# UNITED STATES PATENT AND TRADEMARK OFFICE

09/674,600 12/13/2000 Lorenz Camenzind P/543-103 1539

<b>Office Action Summary</b>	<b>Application No.</b>	<b>Applicant(s)</b>	
	09/674,600	CAMENZIND ET AL.	
	<b>Examiner</b>	<b>Art Unit</b>	
	Gail Verbitsky	2859

## DETAILED ACTION

FIG.8b

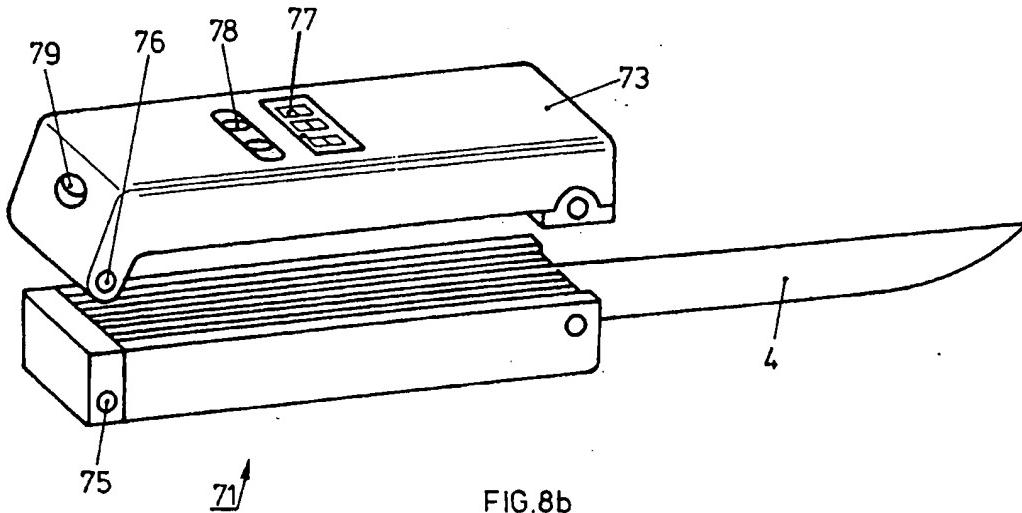
1. The disclosure is objected to because of the following informalities: A) the numeral should be given to the casing in Figs. 2 and 8b and described in the specification. (see paragraph 2).  
B) The Access-Control-Circuit should be described in the specification. (See paragraph of the present Office Action).

2. The drawings filed on 02/02/2007 are objected to because the numeral should be given to **the casing** in Figs. 2 and 8b. Corrected drawing sheets in compliance with 37 CFR 1.121(d) are required in reply to the Office action to avoid abandonment of the application. Any amended replacement drawing sheet should include all of the figures appearing on the immediate prior version of the sheet, even if only one figure is being amended. The figure or figure number of an amended drawing should not be labeled as "amended." If a drawing figure is to be canceled, the appropriate figure must be removed from the replacement sheet, and where necessary, the remaining figures must be renumbered and appropriate changes made to the brief description of the several views of the drawings for consistency. Additional replacement sheets may be necessary to show the renumbering of the remaining figures. Each drawing sheet submitted after the filing date of an application must be labeled in the top margin as either "Replacement Sheet" or "New Sheet" pursuant to 37 CFR 1.121(d). If the changes are
